Engineering Change Notice(ECN)

ECN-D-2602-02

(Requirement for Particle optimization of cable tray near FFU)

NINEBELL

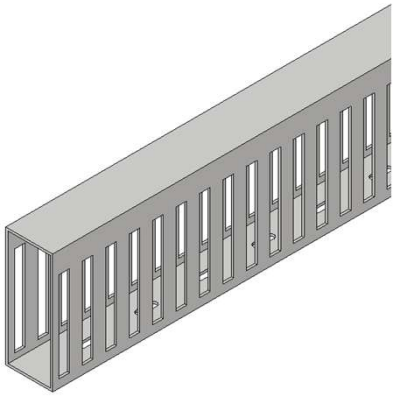
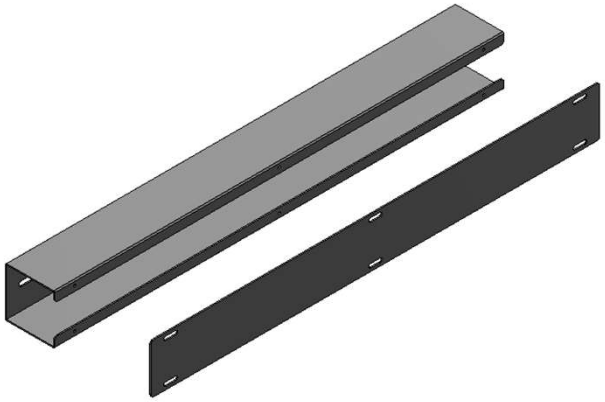
Before(Problems and Change Requests)	After(Expected Effect)
According to on-site feedback, particulate accumulation was found inside the cable trays near the FRU on the process robot.The specific location is shown in the following figure. Please help evaluate such issues and provide reasonable solutions.
